UNITED STATES PATENT AND TRADEMARK OFFICE

10/577,687

Office Action Summary	Application No. 10/577,687	Applicant(s) GORDON, ANGUS BUCHAN	
	Examiner ILYA Y. TREYGER	Art Unit 3761

DETAILED ACTION

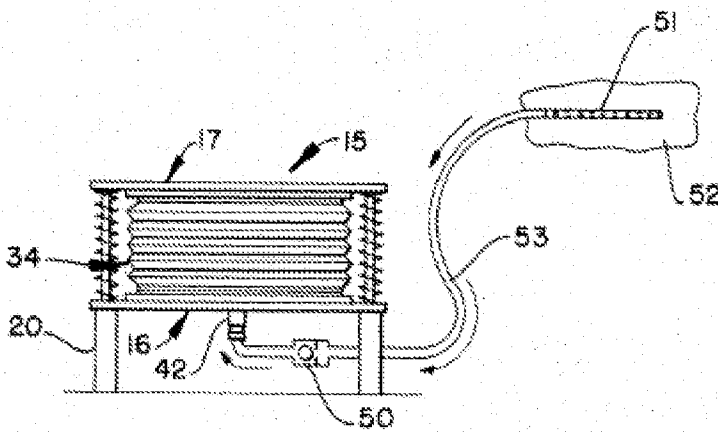
5. In Re claims 1 and 2, Lewis discloses the closed wound suction apparatus (drainage device) 15 comprising:

a pre-evacuated chamber 34; and

a drainage tube 53 connecting the pre-evacuated chamber to a free end portion 51 the

variation of which is the needle (Col. 4, ln. 19-22; Fig.).

9. In Re claim 6, Lewis discloses the closed drainage device wherein the pre-evacuated chamber 34 is cylindrical (See Fig.).

10. In Re claim 7, Lewis discloses the closed drainage device wherein the pre-evacuated chamber 34 is folded since bellows design is a foldable design (See Fig.).

12. In Re claim 9, Lewis discloses the closed drainage device wherein the pre-evacuated chamber is corrugated since bellows is the corrugated design (See Fig.).

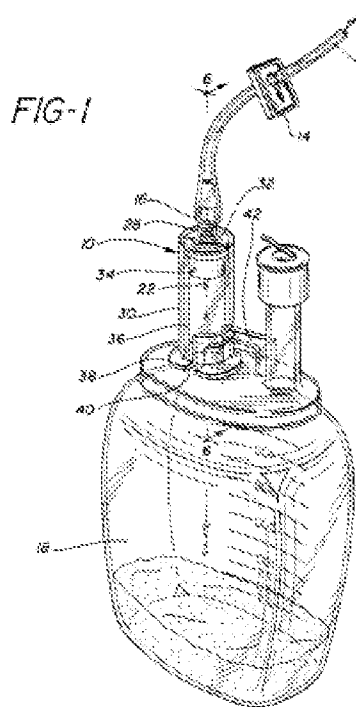
Broadnax teaches the wound drainage device wherein the tube is provided with the sliding clamp 14 (Fig. 1) having closed and opened positions.

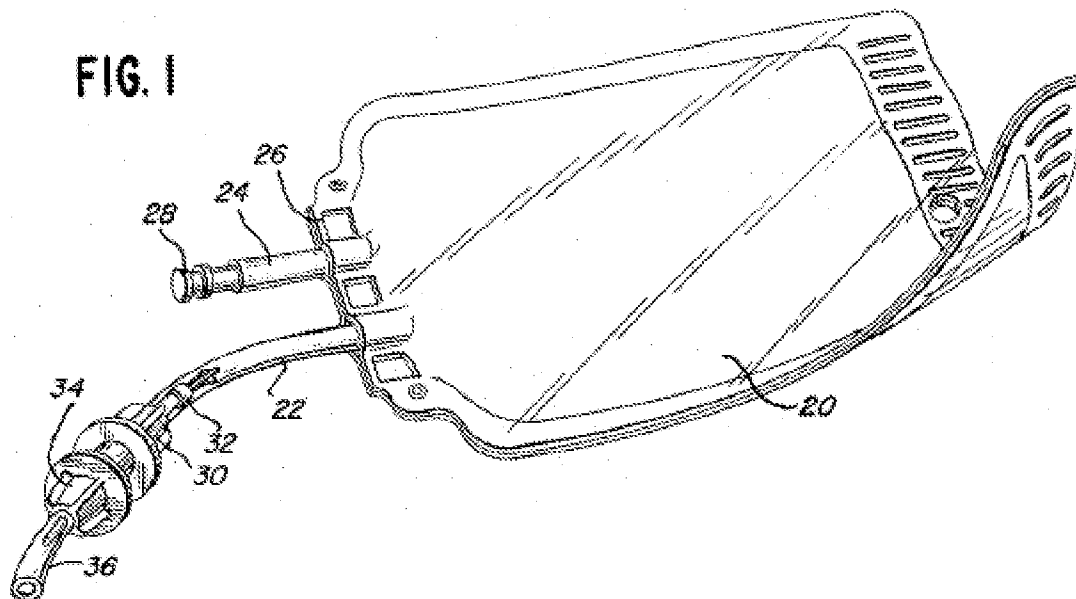
Hogan teaches the use of butterfly needle 16 for draining the body fluids from the patient (See Fig. 3).

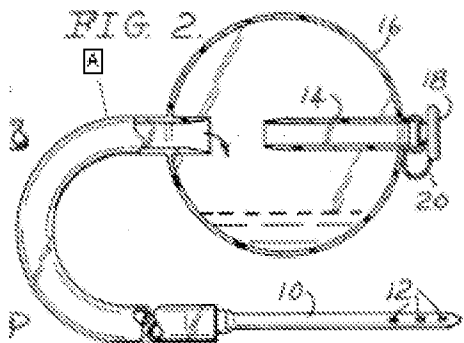
Friend discloses the device for draining a body cavity comprising:

a flexible reservoir 16 (pre-evacuated chamber); and

a drainage tube A connecting the pre-evacuated chamber 16 to a needle 10, wherein the vacuum port 14 has a plug 18 (See Col. 4, ln. 13, 14; Fig. 2).
